ADDENDUM NO. 3 – May 18, 2026

**Missionary Minnie Lee Cotton Park Restroom
CIP PK 26-21**

This addendum amends the Contract Drawings and Specifications for this project as follows:

A600

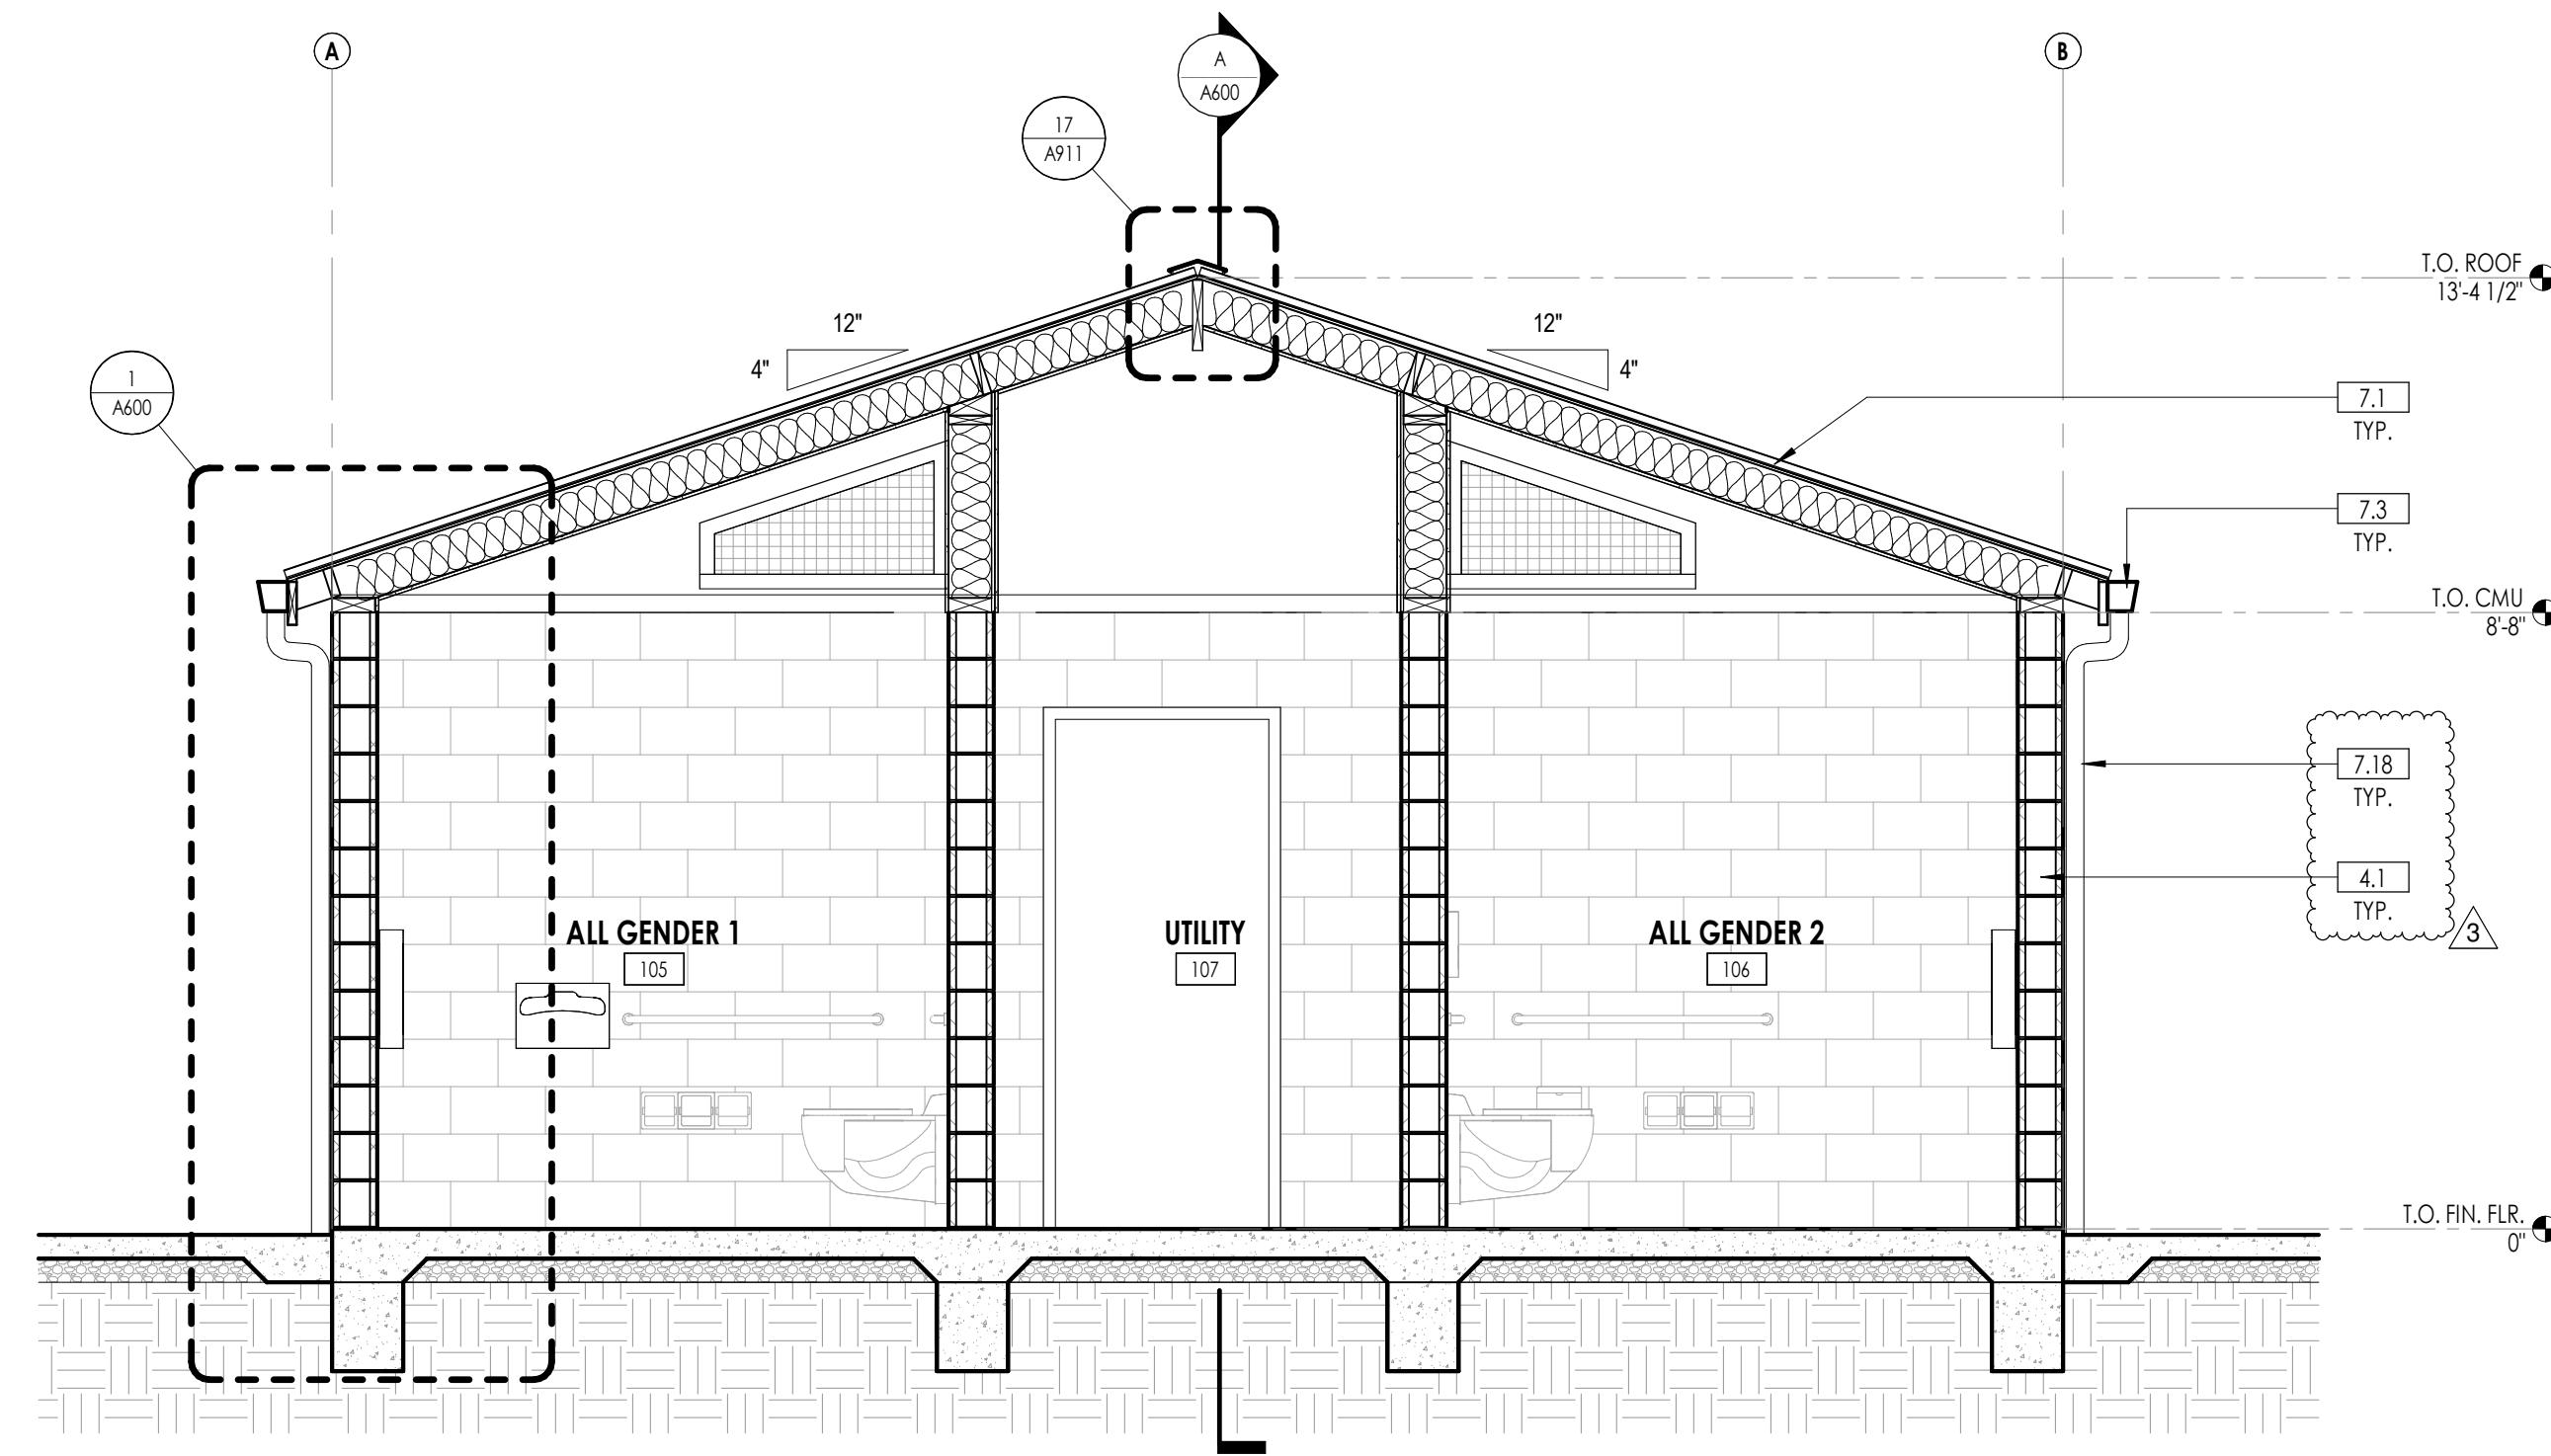
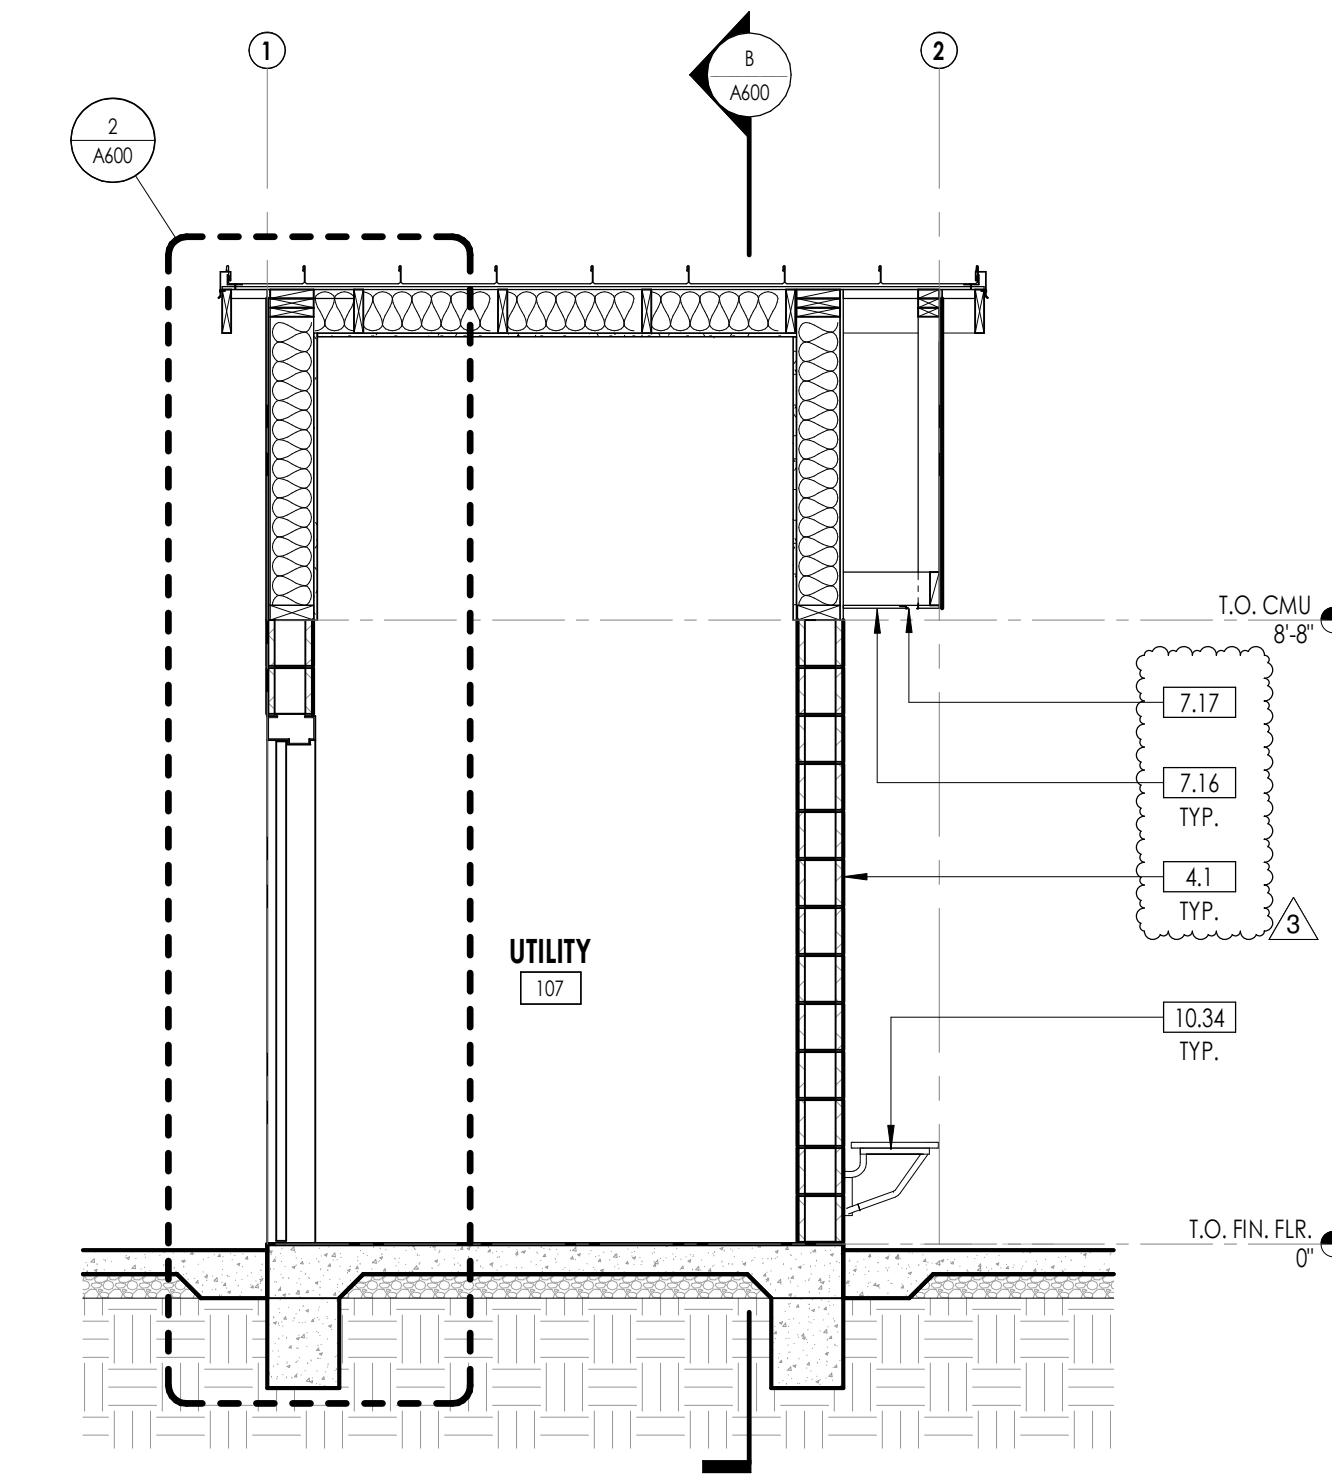
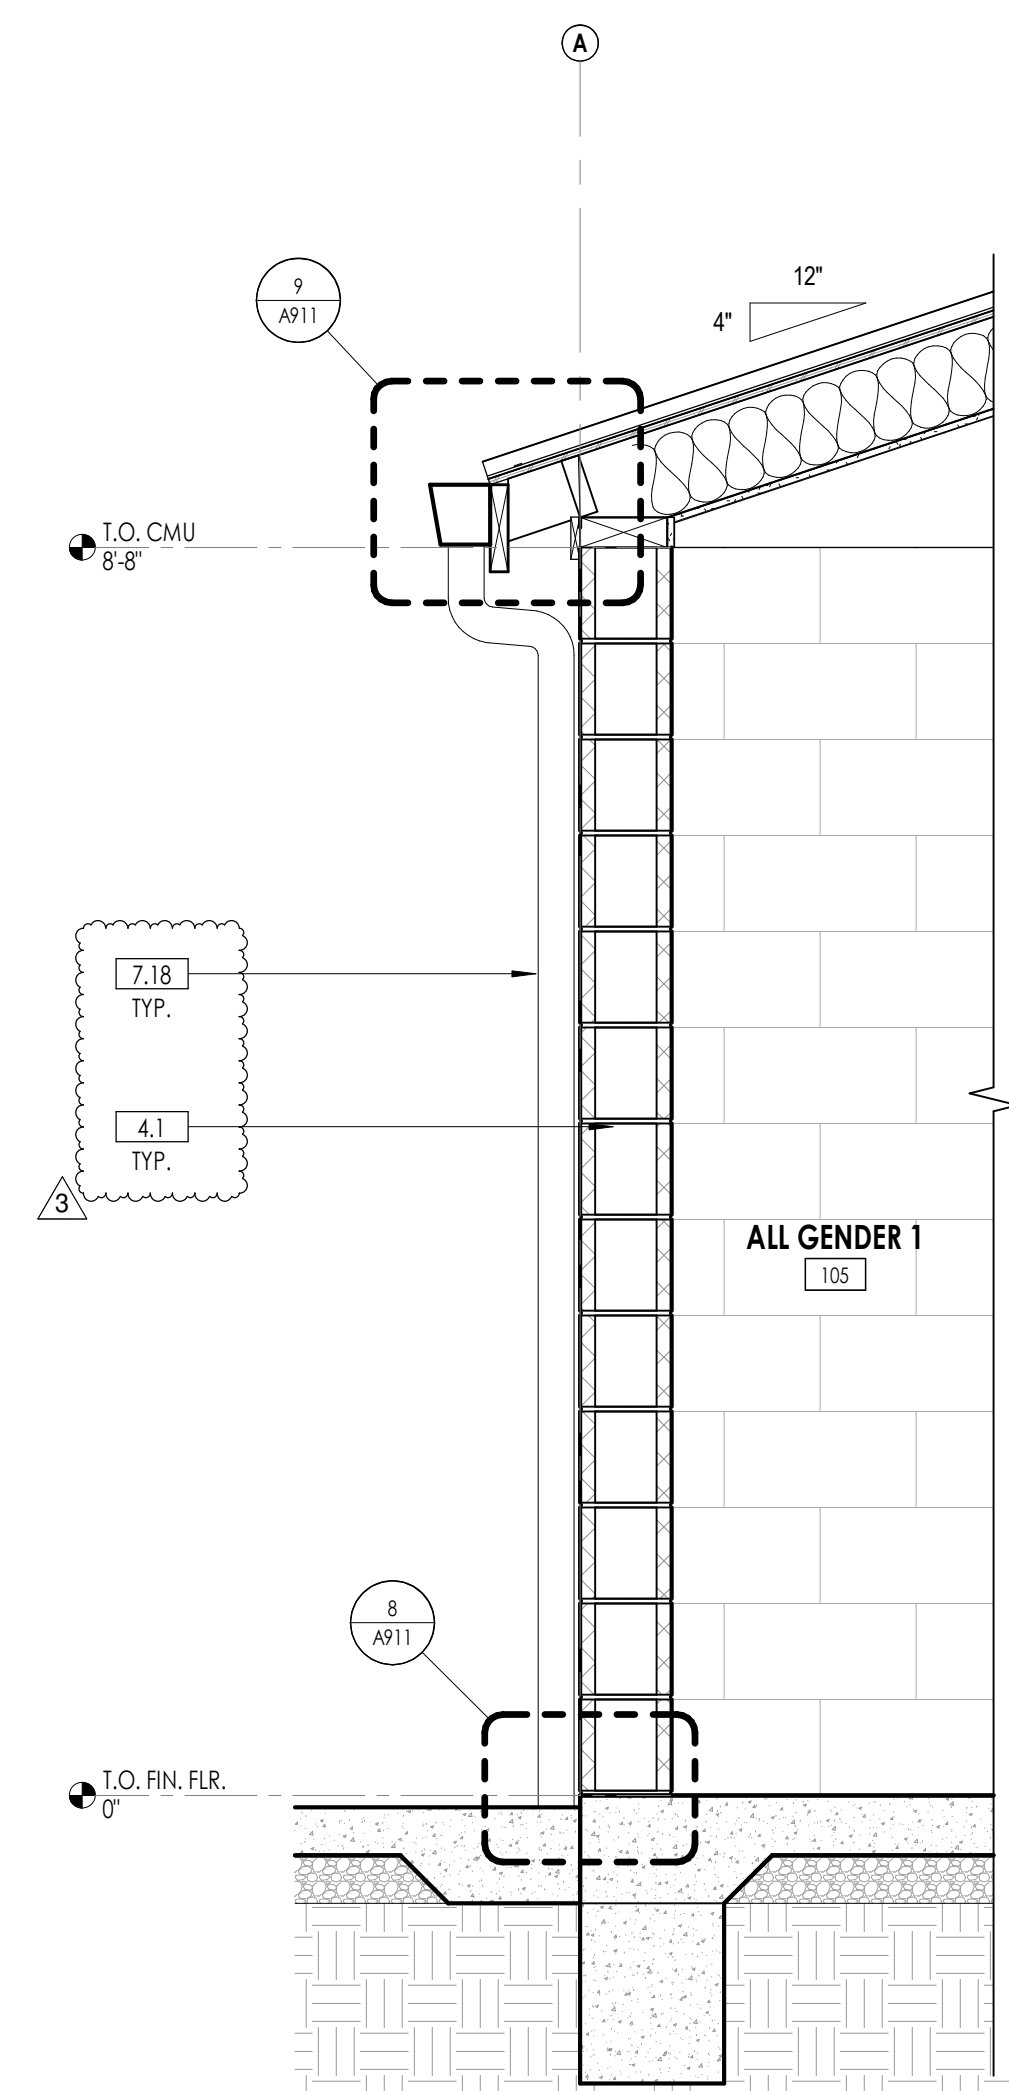
RFI 5: Key Note 3.7 is missing from Sheet A600, please provide.

A5: See attached revised sheet A600, tag 3.7 has been revised in the keynote schedule as 4.1 – see sheet A600, delta 3.
